WATER RESEARCH 40 (2006) 851–852

Erratum

Erratum to "Modeling monochloramine loss in the presence of natural organic matter" [Water Research 39(14), 3418–3431]

Fig. 1 – Schematic of monochloramine reaction pathways in the presence of NOM. DOC_{ox} represents oxidized NOM.

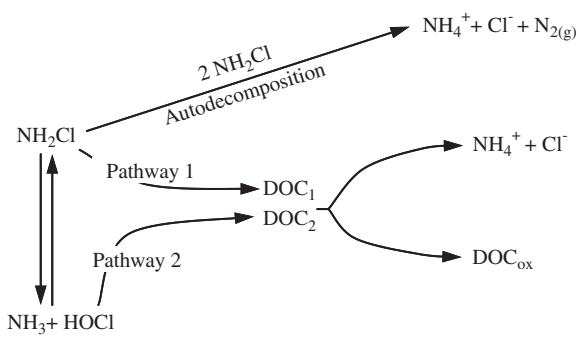
Page 3422, Fig. 1—Hypochlorous acid in the monochloramine reaction pathway schematic should be HOCl and not HOCl3.

Fig. 5 – (b) Ammonia formation as a function of pH in IRWC. $[NH_2Cl]_o = 0.05$ mM, $[TOTCO_3] = 4.0$ mM, $\mu = 6.0$ mM, temperature = 25 °C, Cl/N = 0.7 mol/mol and [TOC] = 3.3 mg C/L. Lines represent model results.

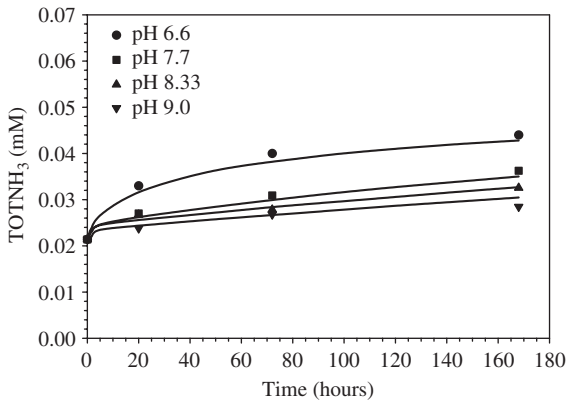
Page 3426, Fig. 5b—Figs. 5(a) and (b) are the same figure. Fig. 5b should show ammonia formation due to monochloramine loss in the presence of IRWC.
